Road Safety Audit
Stage 1
for
BRAY SUSTAINABLE TRANSPORT BRIDGE
BRAY, CO WICKLOW

Date: September 2020

Report produced by: Road Safety Matters Ltd

Reference: RSM/MOB/130320/DARGLE BRIDGE-RSA1

Figures 28 & 29: Significant level differences and gradients at Junction 2

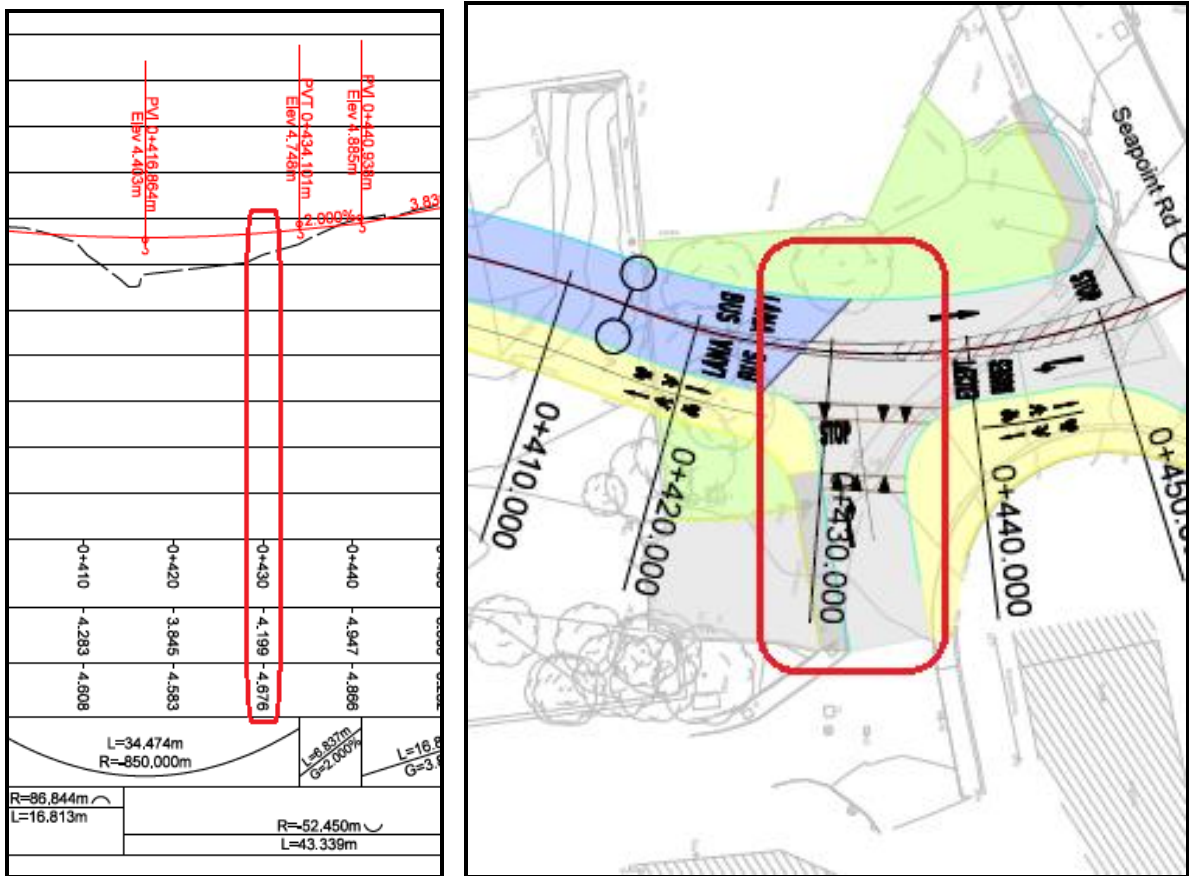
Figure 28 also highlights a steep gradient of 3.83% over a distance of almost 17m at the southern scheme tie in at junction 2. This coincides with a location where geometry is already restrictive, as outlined previously in paragraph 2.2.2. The vertical design at this location also appears to indicate a level difference of almost half a metre at the tie-in with the access road to Seapoint Court, which is at chainage 430m, as shown in figures 29 and 30. Inappropriate gradients and uneven carriageway levels on approaches to junctions can increase risks, including overturning risks for larger vehicles particularly in wet and icy conditions.

Forward visibility and SSD should be clear and unobstructed at all times in accordance with traffic speeds, particularly on approaches to VRU crossing points, where VRU priority and safety should be maximised. The vertical design for the scheme should be reviewed taking into account all issues raised above, with the design to be amended where possible to provide flatter gradients, taking into account drainage requirements to minimise the risk of standing water.

Relaxations from minimum required should be isolated from other relaxations, on both the horizontal and vertical planes. Final design should ensure there are no sudden changes in level particularly at junctions and locations where vehicles will be turning within a relatively confined space, and where the risk of overturning is higher. Detailed design contours should be checked at this location, and at all others throughout the scheme, to ensure surface water is adequately drained and that ponding will not occur within the carriageway, leading to an increased risk of loss of control during wet and icy conditions.

Figure 30: Minimal Clearance between boundary and carriageway

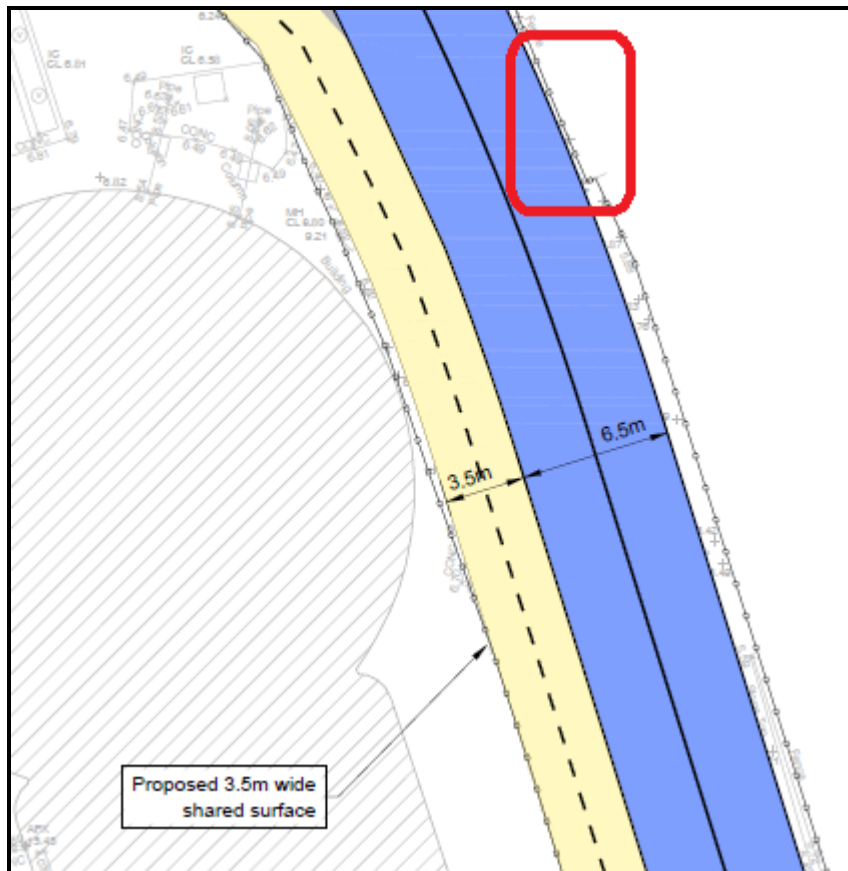
Significant variations in cross section were noted over relatively short distances. Cross sections show that the carriageway width reduces from 8.2 (7m plus lateral clearance of 600mm to each side) to 6.5 on each side between ch 200 and 225m, and also reducing from 8.2 to 7.8m from 275-300m, and from 7.8m to 6.5m between ch 300m and 325m. Sudden changes in cross section and lane widths, particularly without sufficient warning, or at locations which coincides with relatively sharp curvature, or locations where forward visibility may be restricted, can lead to an increased head on or side swipe collision risk, or an increased risk of mounting the pavement or striking hazards in close proximity to the carriageway.

Insufficient clearance has been provided to the continuous linear hazard presented by the fence/wall at approximate chainage 300m, as shown in figures 30 and 31, where a lateral clearance of only 0.2m is indicated. The plan shows no clearance to the bridge structure, as shown in figure 32, between approximate chainage 210m-300m

Sufficient safe clearance should be provided between the carriageway edges and all street furniture and potential hazards along the length of the route. Any changes to cross section width should be implemented gradually, with sufficient advance warning regarding the narrowing ahead to ensure drivers can adjust their speed accordingly. Conservative SSD should also be applied on any locations where combinations of horizontal and vertical curvature may lead to reduced forward visibility in advance of hazards such as a reduction in carriageway width.

Figure 33: Cross section differing to plan proposals at ch 450m

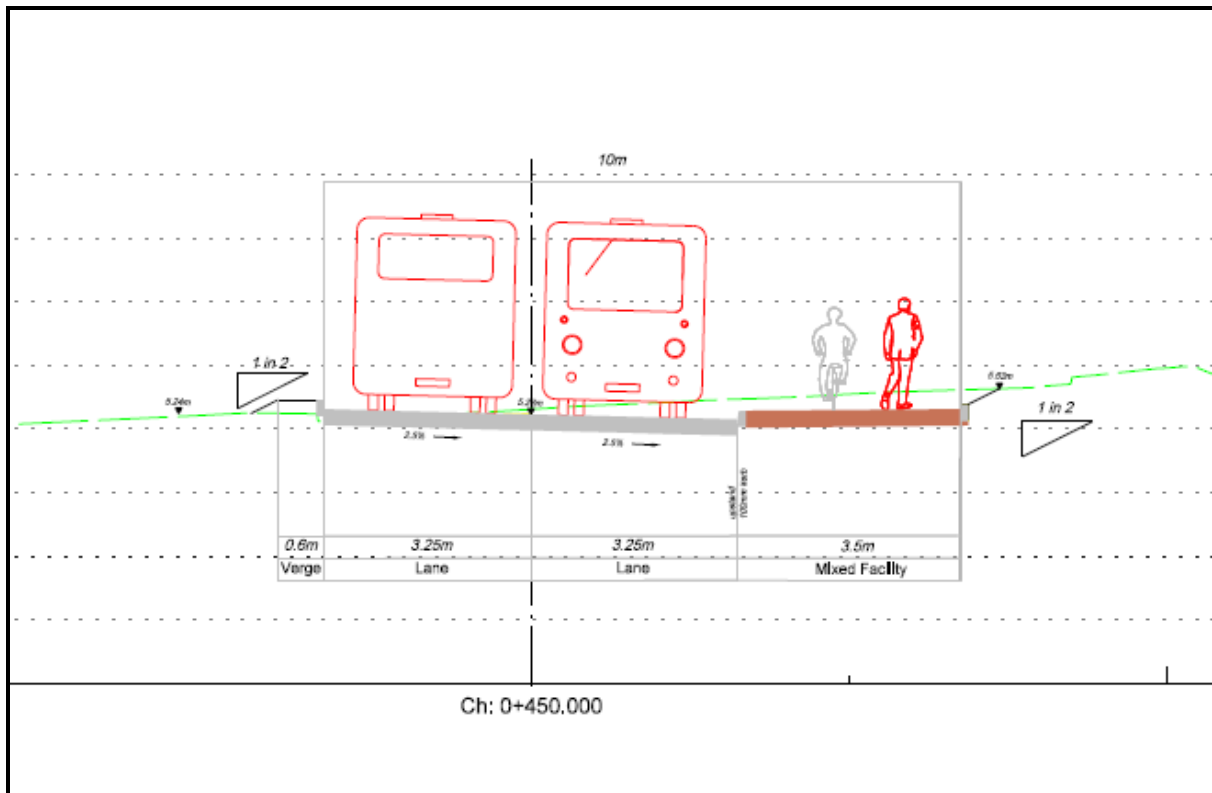
The cross sections show that continuous crossfall or superelevation of 2.5% has been applied across the full cross section from the more northerly channel. It was noted that chainage 320-360m approximately is located on a straight section of horizontal alignment, however superelevation/crossfall has been shown across the full cross section, rather than from the centreline of the carriageway to assist with positive drainage and to minimise overturning risks for higher vehicles. The same was noted on the cross sections for the straight alignment from chainage 120-220m approx. It was also noted that the cross section at ch 450m, which is shown in figure 33, does not reflect the widened carriageway with central hatching or the wider shared surface and verge at this location.

Figure 34: High Kerbs at private drive access

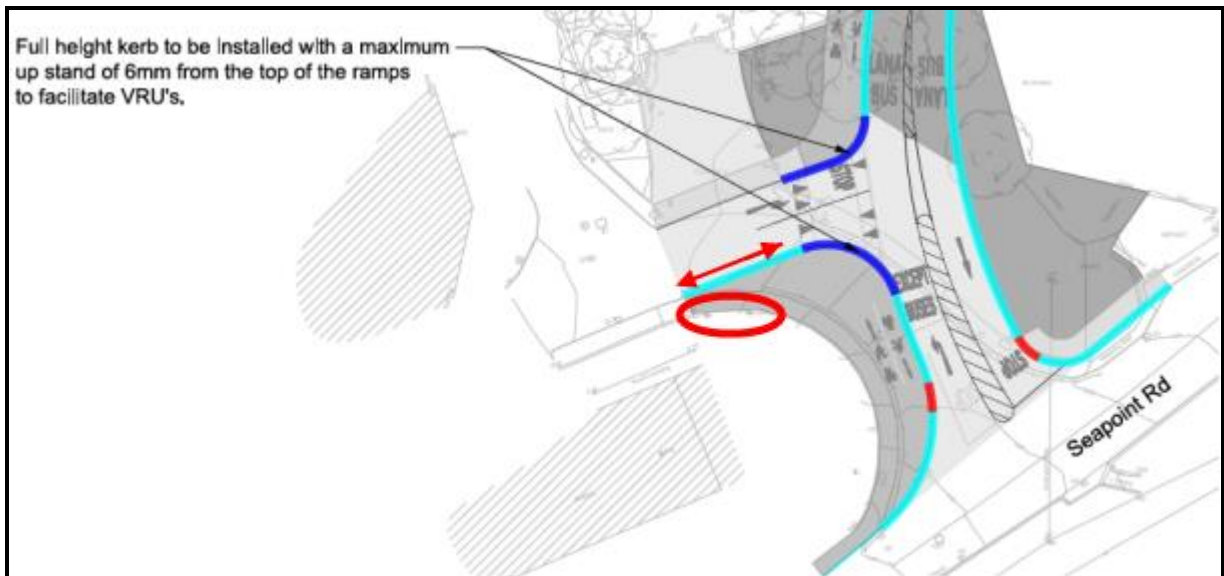
It was noted from the kerb drawings that a full height kerb has been provided at the private driveway access at Junction 2, which is shown in figures 34 and 35, which may present difficulties for safe access and egress at this location.

Suitable dropped kerbs should be provided to facilitate access and egress to and from the driveway at this location and at all other locations where vehicular access will be required. A maximum kerb upstand of 6mm should be provided on all pedestrian desire lines.

Figure 36: Narrow Shared Facilities

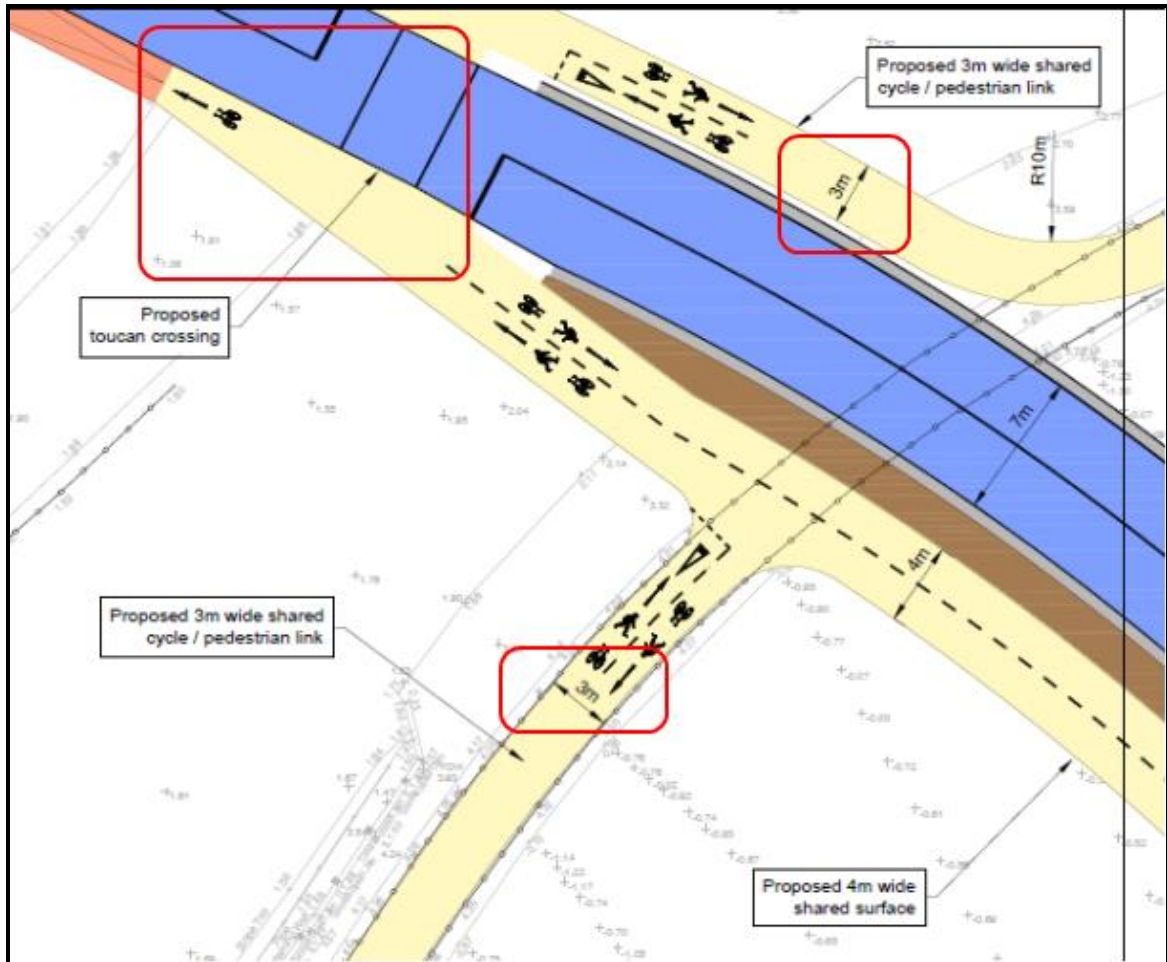
2.3.1.1 The proposed route will provide a segregated off-road cyclist facility, which will safely accommodate one-way cyclist movement along the link, however the facility is provided on one side of the carriageway only, and it does not appear to be sufficiently wide to accommodate two-way cycling movements along the entire length of the proposed link, particularly on the narrower sections of shared space. There is no provision on the design for a verge or separation distance between the VRU facility and the carriageway. When cycle/pedestrian facilities follow the route of a road, a separation distance should be provided between the road and the cycle track through the provision of a grassed verge. A minimum grassed verge width of 1m is usually required to improve safety for VRUs. Figure 36 shows 3m wide shared facilities, including on approaches to the proposed toucan crossing, which would only safely accommodate one-way cycling movement alongside pedestrians. Figure 37 shows a narrow shared facility with hazards immediately adjacent to the VRU facility on both sides, which would normally warrant increased widths on the VRU facility.

Likely cyclist volumes and desire lines should be considered in provision of safe continuous facilities along the route, with provision for suitable separation distance as necessary, and sufficient width to be provided to minimise the potential for conflict between cyclists and pedestrians. Where the cycling and pedestrian routes are segregated by a kerb, a minimum width of 2m is recommended for the pedestrian side, and a 2m effective width for the cycle side (one way). The effective width of the cycleway should be measured from the back of kerb and not the running edge of the carriageway. A width of 3 metres is the preferred two-way minimum width on a cycling route which is not shared with pedestrians, but only where the route is not bounded by vertical features. Where a significant amount of two-way cycling is expected, additional width should be provided, depending on anticipated user flows. Additional width should also be provided for spaces which are to be shared with pedestrians on the same level.

If vertical objects such as a wall, a fence or items of street furniture such as lighting columns are located immediately adjacent to a cycle facility, the effective width of the cycle facility will be reduced. A minimum lateral clearance of 0.5m shall be provided to vertical objects where they are located adjacent to cycle facilities. The need for two-way cycleway provision or otherwise should be clarified, with widths of all facilities increased where necessary subject to maintenance of safe two-way traffic movement on the carriageway. Shared facilities next to vehicular traffic should have a recommended combined width of 4m with the absolute minimum combined width of 3m acceptable in locations which cater for just one-way direction of travel for cyclists. All cycling facilities should have a design speed of 30 km/h and suitable intervisibility should be provided at all intersection points with a reduced design speed of 10 km/h acceptable (over short distances) on approaches to junctions.

Figure 38: Level Differences at northern side of bridge

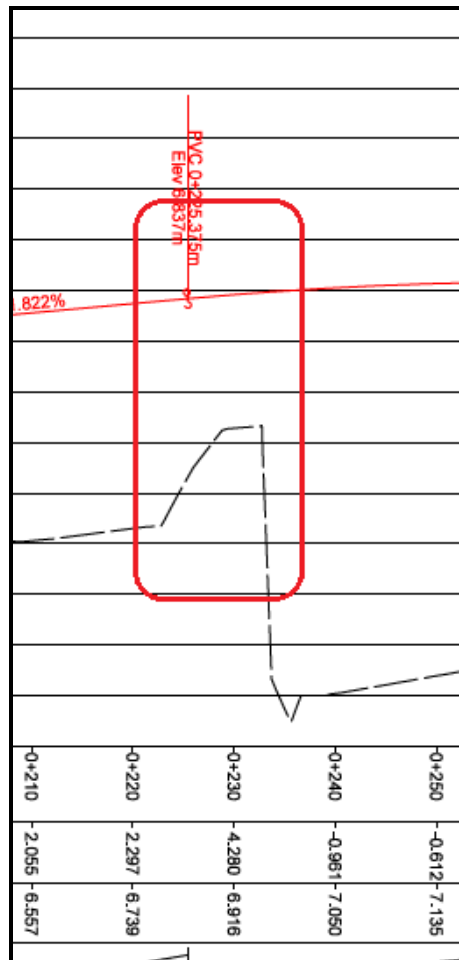
2.3.1.2 There were no details provided for the bridge deck, and no clearances shown between the bridge and the VRU route below, however significant level differences were noted on the long section. The photo in figure 40 shows current levels adjacent to the track at this location. It is unclear how the levels and gradients will work for the connection between the existing two-way cycle track parallel to the river and the new shared surface and toucan crossing adjacent to the bridge, and the scope for direct safe connectivity of the cycling route underneath the bridge is

unclear, which would prevent the need for diverting from the direct desire line and crossing the carriageway in direct conflict with vehicles.

The connectivity and gradients of the shared facilities should be clarified. A desirable maximum gradient of 3% should be provided on the cycling facilities, with a maximum gradient of 5% on the footways. Safe segregated VRU facilities are preferred to those which require travel across the path of motorised vehicles, at a location where intervisibility may be compromised, as outlined in paragraph 2.3.3, or on sections of route which may have potentially steep gradients, which could present difficulties for some road users, particularly elderly and mobility impaired pedestrians, and particularly in wet and icy conditions. Consideration should be given to continuity of the existing VRU route underneath the bridge, with headroom standards to be provided in accordance with DN-GEO-03040. The desirable minimum headroom along cycle facilities is 2.7 metres, however over short distances a reduced head height of 2.4 metres is acceptable.

Figure 41: Level differences at proposed footway

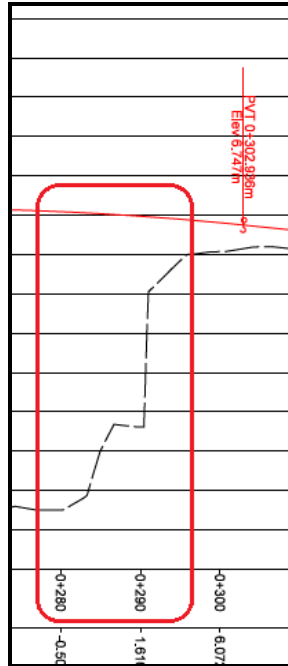
A significant level difference was also noted on the southern side of the bridge at approximate chainage 290m, where the tie-in details and gradients for the proposed footway are unclear, as shown in figures 41 and 42.

Figure 42: Cyclists vulnerable on narrow cross section

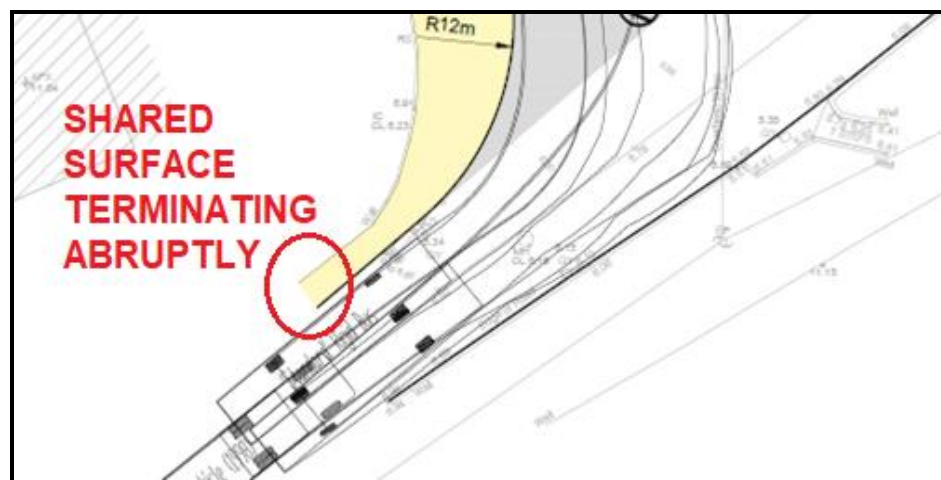
2.3.1.3 It was noted that the proposed shared footway/cycleway terminates abruptly at Junction 2, where there is no provision for dropped kerbs to facilitate transfer from on to off road facilities, and there is insufficient space on the narrow existing footway at the tie-in to facilitate safe shared use. The restrictive geometry at Junction 2, as outlined in previous sections of this report, will present risks for cyclists at this location. Two wheeled vehicles, including motorcyclists, are particularly vulnerable in narrower lanes at and on approaches to junctions, with insufficient space to queue and move alongside larger vehicles. Narrow lanes can also increase the risk of sudden braking and rear shunt collisions, as well as side swipes and kerb collisions.

The safe continuity of the new cycling infrastructure should be considered at the southern scheme tie-in on Seapoint Road. Clear signage should be provided regarding the start and end of all facilities on the cycling network, to be included on plans at detailed design stage. Safe transitions from off to on road facilities will also need to be provided at the southern scheme tie-in, along with suitable warning signage to alert drivers to the potential presence of cyclists in the carriageway. All lane widths on the links at the tie-in points should be sufficiently wide to cater for safe cyclist movement.

Figure 44: Wide crossing distance

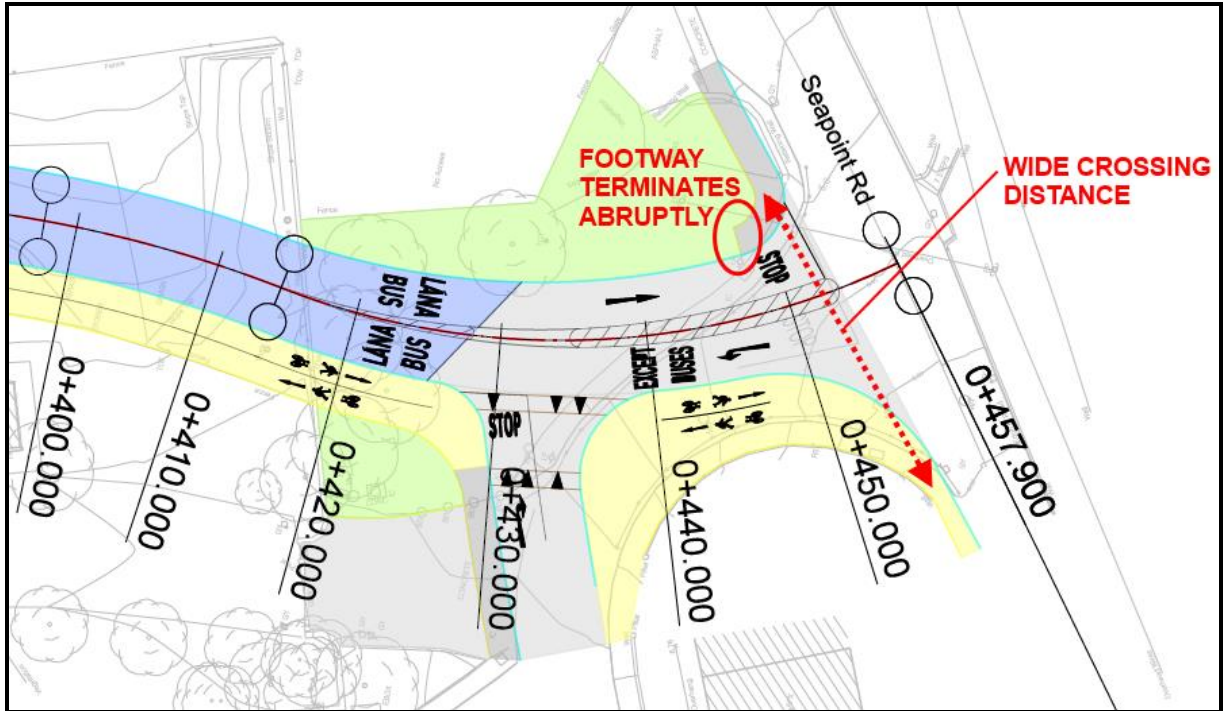
2.3.2.2 A wide crossing distance was noted at the intersection with Seapoint Road, with no provision for a pedestrian refuge, to minimise the crossing distance, particularly for older and mobility impaired pedestrians. Pedestrians, particularly the mobility impaired and elderly are more vulnerable on crossing distances exceeding 10m without provision for refuge. VRUs will be particularly vulnerable at this location, where a high proportion of larger turning vehicles, i.e. buses, will be turning as a result of the proposed new bridge and link road. The footway on the eastern side of the junction also terminates abruptly, with no provision for safe crossing to the footway on the opposite side of the carriageway, and no provision for dropped kerbs and tactile paving for the benefit of visually and mobility impaired pedestrians. The crossing distance will be somewhat shortened by the proposed kerb buildout on western side, however this will impact on existing utilities, and it was noted that chamber covers will be located within pedestrian desire line, where they may present a slip hazard.

Crossing distances should be less than 10m. Where VRUs must cross the carriageway in one movement exceeding 10m wide, a minimum refuge of 1.5m should be provided, subject to swept path analysis, with provision for prohibited movements and HGV/3T limits if necessary, to ensure VRU accessibility and safety is prioritised. Footways should be continuous, and should not terminate abruptly without provision for safe crossing on the opposing side of the carriageway at a safe location.

Figure 48: Pedestrian desire Line at Junction 2

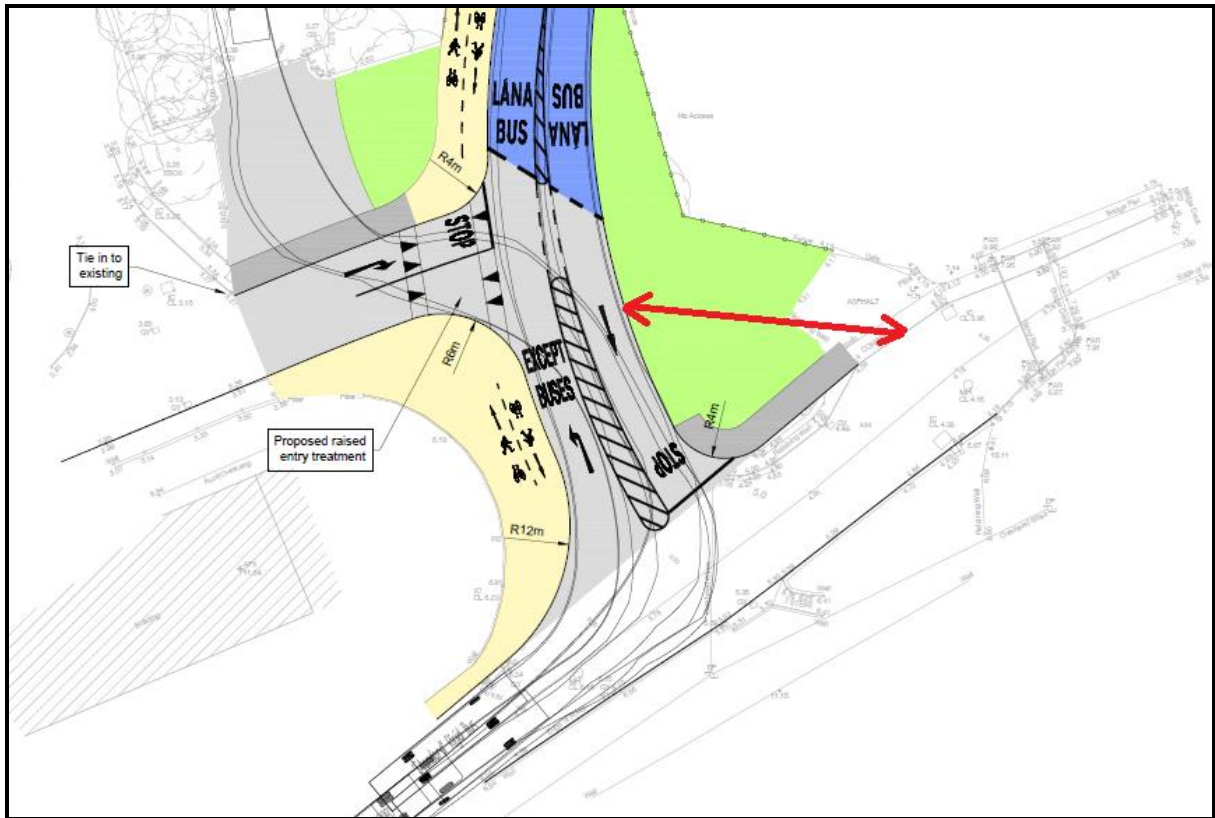
2.2.3.3 A pedestrian desire was noted on site at Junction 2, as shown in figures 47, 48 and 49, which has not been catered for on the proposed layout.

Continuous footways with a minimum width of 2m should be provided on all likely pedestrian desire lines, on the most direct route.
